4.55(1A) MODIFICATION NO.6 OF MINISTERS APPROVAL FOR MP 07_0179 – TSC DA NO. 09/0830 –NO. 6.

To seek modification to a development consent being for a Part 3/Part 4 storey mixed use development entailing ground level commercial including supermarket and retail shops, upper level residential units, basement and surface car parking and landscaped areas.

Lots 184 – 187 & 191-194 DP 259164 and Lots 20-23 DP 31208, Tweed Coast Road and Hastings Road, Cabarita Beach/Bogangar (now known as Lot 1, DP 1185345, 39 Tweed Coast Road, Bogangar)

September 2020

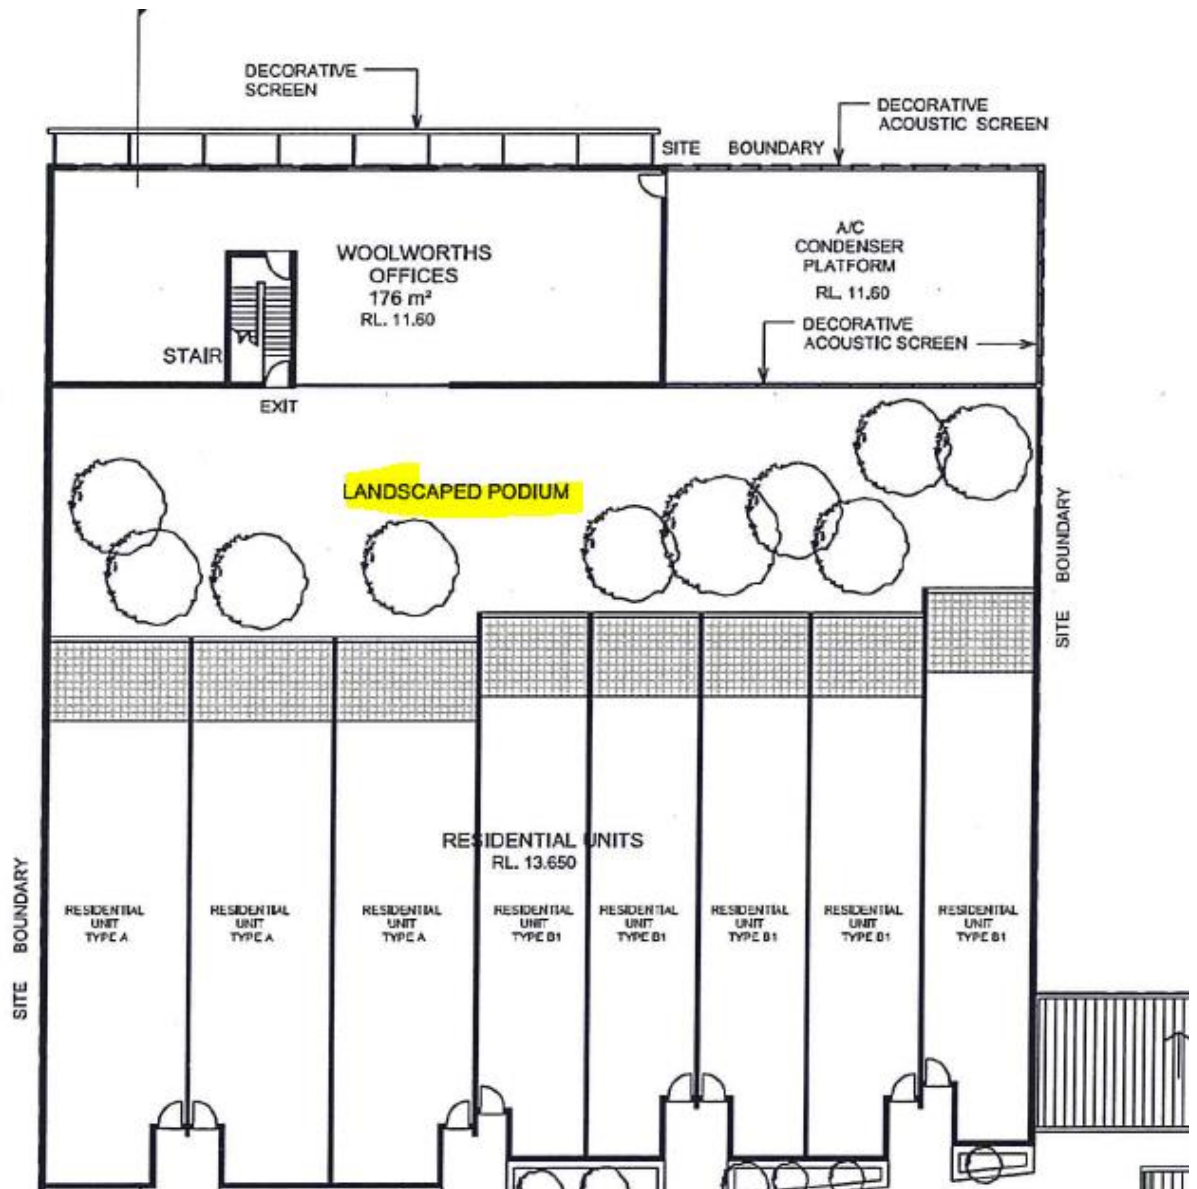
Minor Changes to the approved architectural plan set have been clouded in red within the attached plan set. These amendments to the approved design are in response to the amended residential component of the developments and its connectivity with the ground floor commercial premise. The amendments will improve the overall amenity for residents and occupants of the residential development, while not being discernable changes from a visual perspective.

These amendments will improve the functionality of the development for residents and occupants and reflect modern design trends. These design changes are of a minor nature and will not alter the overall appearance of the development from adjacent properties or public open space. The changes will not increase the bulk and scale of the project nor will the changes impact the approved floor space ratio, building lines and setbacks.

Extract Plan Title; Level 1 Floor Plan DWG DA-05 Rev B

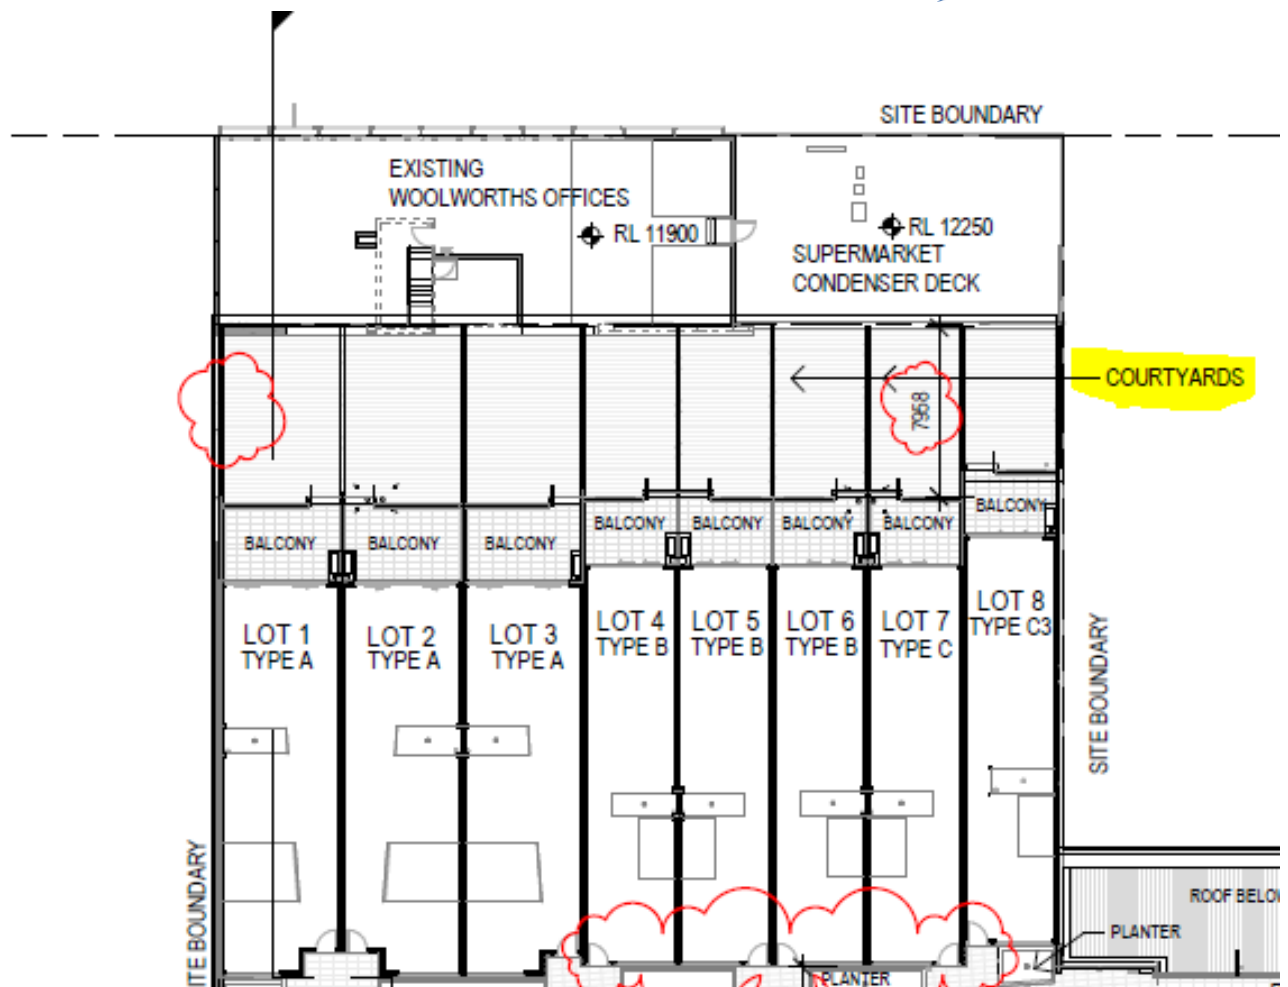
The original development, as approved included the provision of 192m² of landscaping to an inaccessible roof area upon Level 1. The inaccessibility of this landscaping area is not considered a feasible option for ongoing maintenance and is not considered a functional or reasonable component of the development. As an alternative, this area will be utilised by Units 1- 8 as private open space. Each Unit will be allocated additional areas of private open space, enabling these units to maintain these areas.

Landscape Podium as Approved

Proposed Alteration to Level 1 – Courtyards Previously known as the Landscape Podium

*Proposed Landscape Areas in yellow (previously known as Landscape podiums) – Plans
Extract – Plan Title; Sections - DWG No DA-10 Rev B*

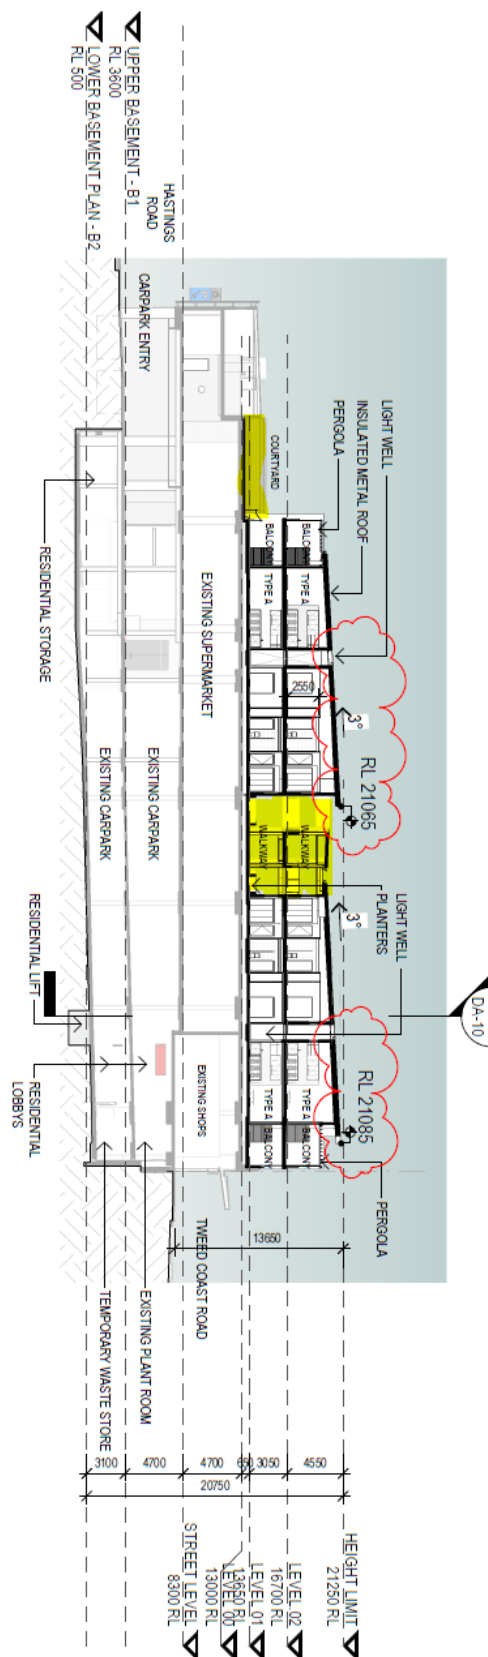
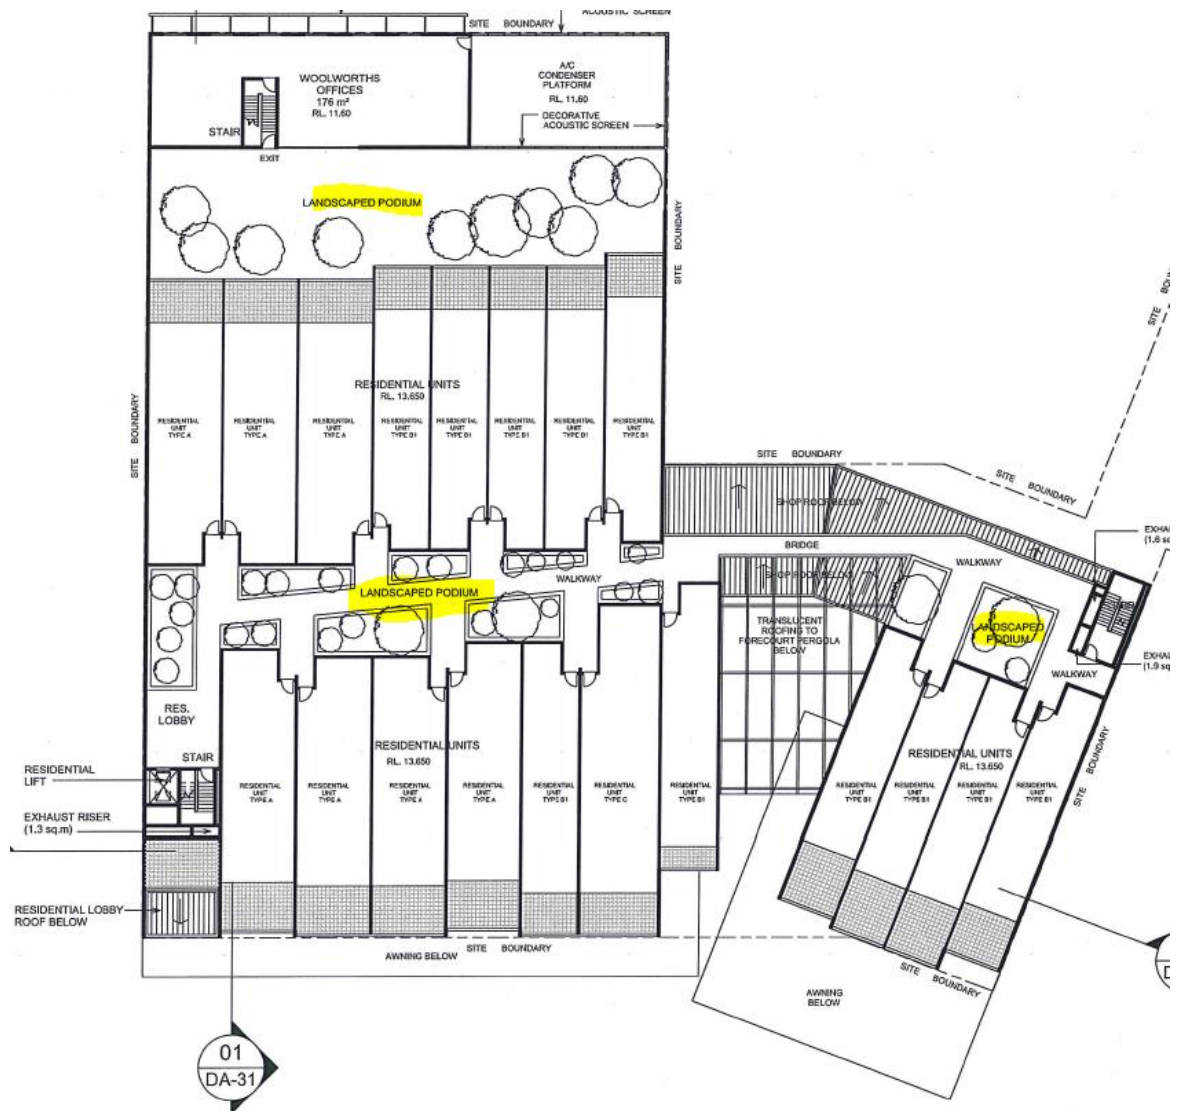
The conditions of consent required an increased separation for improved landscaping areas between the two rows of Units at Level 1. This has been achieved by the increased separation between units by 2000mm on both levels as required by the conditions. It is noted that the RFDC did not nominate a minimum area for landscaping, rather the development consent conditions required a widening of the area by a total of 2000mm, which has been complied with.

The table and highlighted extracts from the approved and proposed plans below demonstrate the increased separation between the eastern and western blocks with minimal reduction in the cumulative landscaped areas.

Extract Approved Plan Set- Approved Landscaped Podium Areas in yellow – Plan Title; Sections - Stage 2
– DWG DA-31 Rev A

Extract Plan Title Level 1 Floor Plan DWG DA-05 Rev B

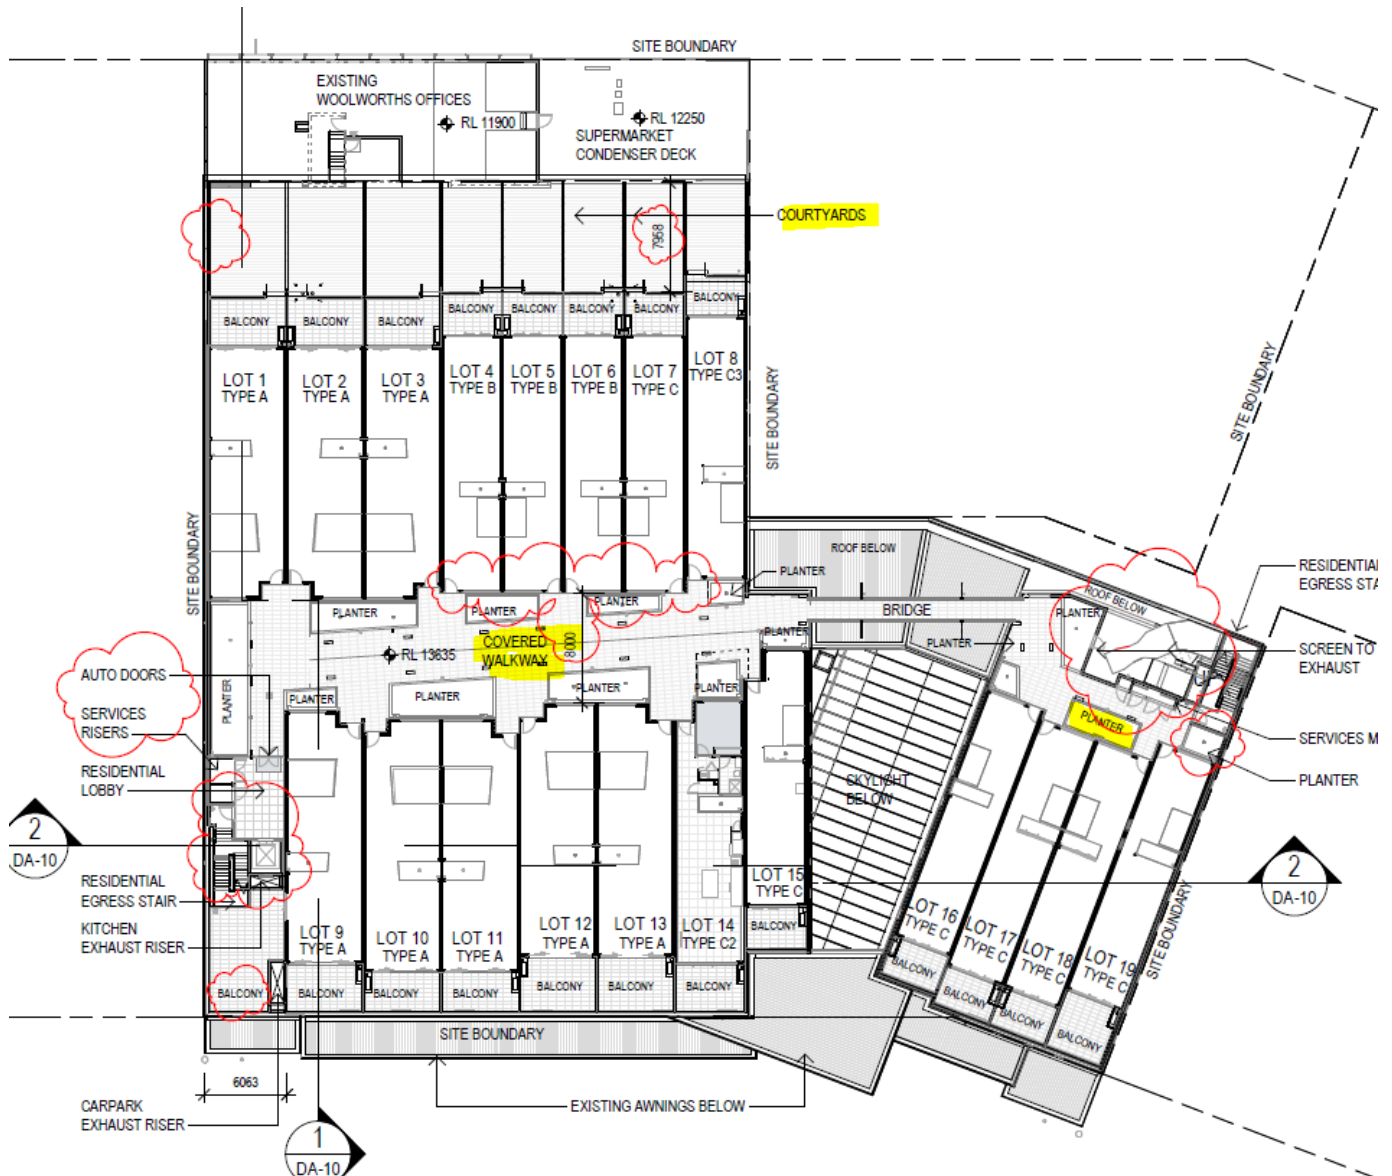
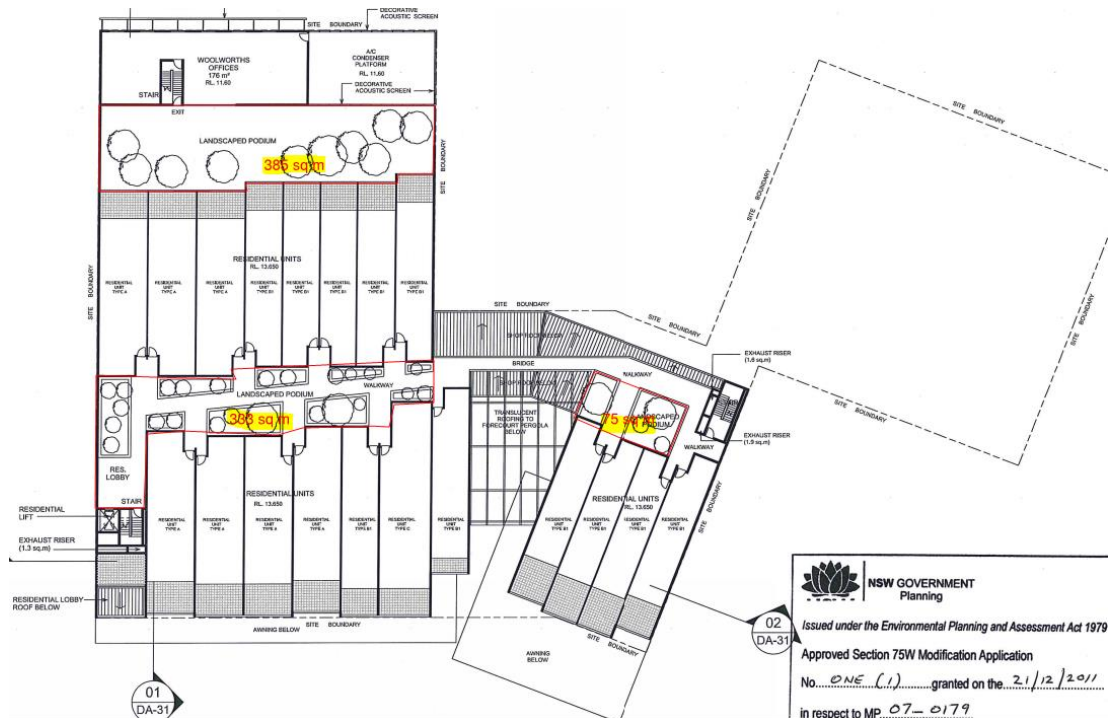
Landscape Podiums as Approved

Extract Approved Plan Title; Level 1 Plan – Stage 2 - DWG No - 05 Revision B

*Proposed Alteration to Level 1 – Courtyards Previously known as the Landscape Podium –
Landscape Podium renamed as covered walkway*
